**Village of Haverstraw
40 New Main Street
Haverstraw, NY 10927**

INQUIRY RESPONSES

**DOWNTOWN PARKING AND COMPLETE STREETS
FEASIBILITY STUDY**

DATE OF RESPONSES: SEPTEMBER 23, 2024

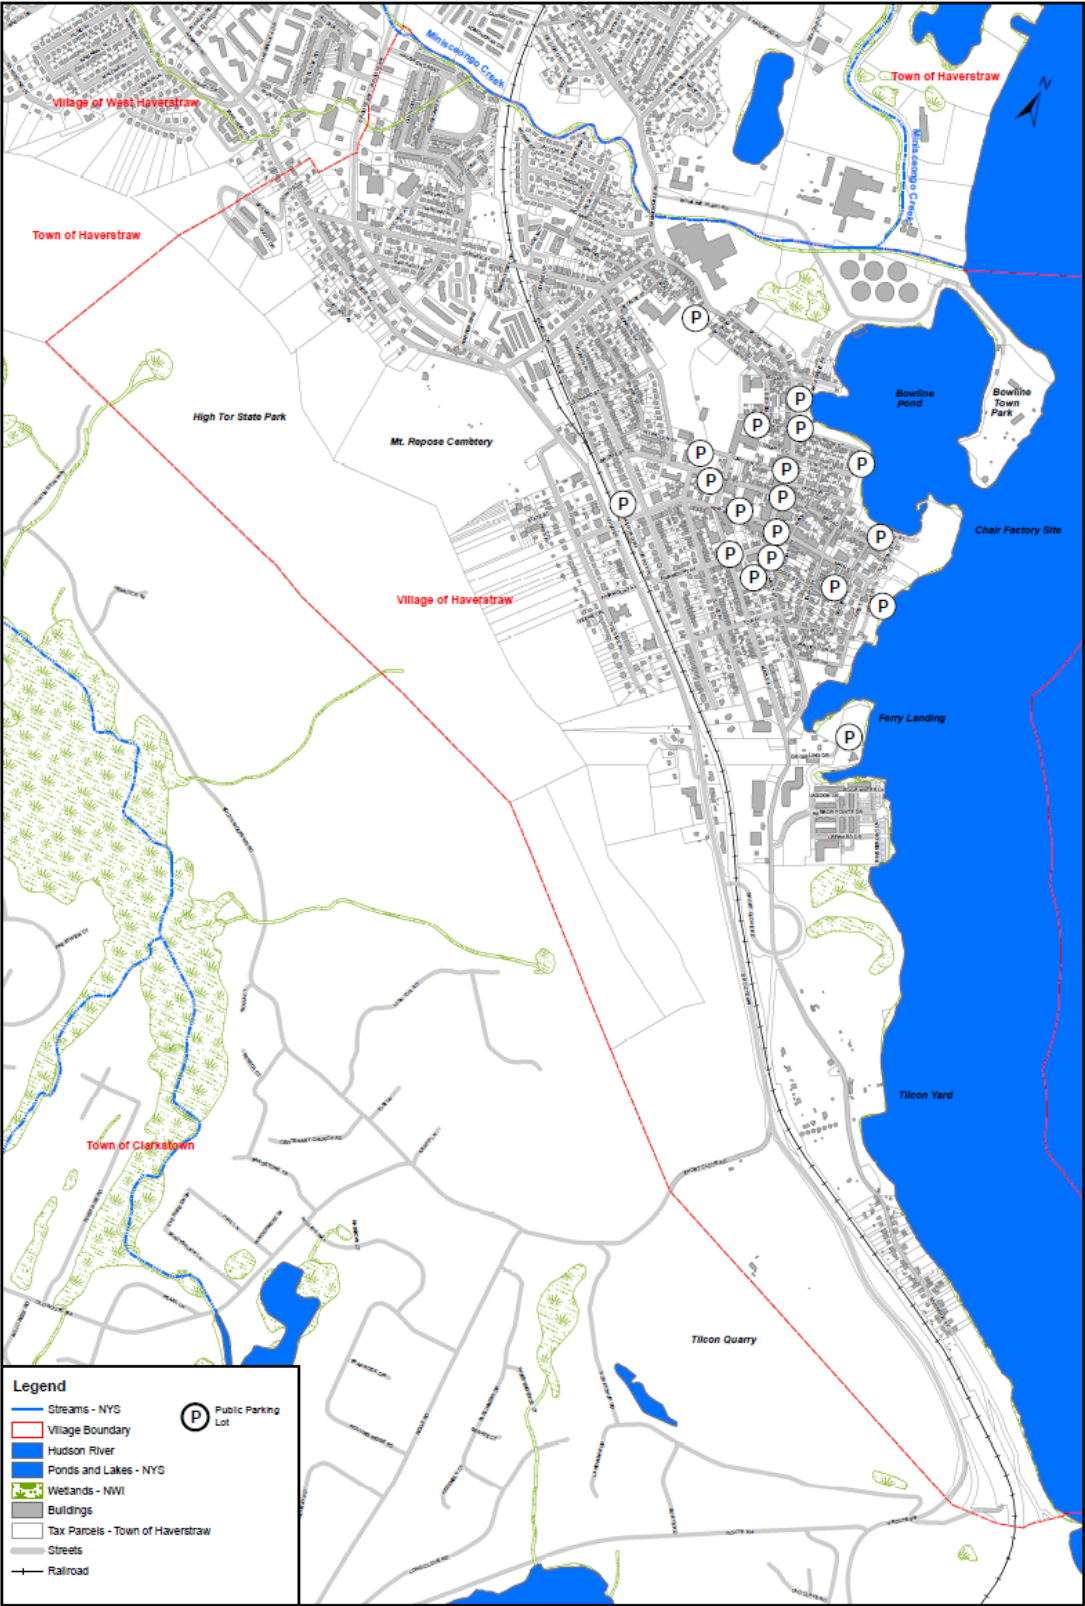
6. Is there a map of the streets on which this study will focus on?

- 13. At the field visit on 9/12/24 it was noted three key intersections should be considered under this project (Scope of Work #8). Can you please identify those locations?**

- 21. The title for this RFP is “feasibility study” and a final report is the deliverable. Is determining feasibility the goal or is the goal to provide the Village with fully-engineered construction plans for three locations? Or is it both?**

The study area will include the streets and key intersections on the attached map below.

The three key intersections are identified on the attached map.

The goal is to develop alternative solutions in these three key areas. We are not expecting a set of full engineering plans at this phase.
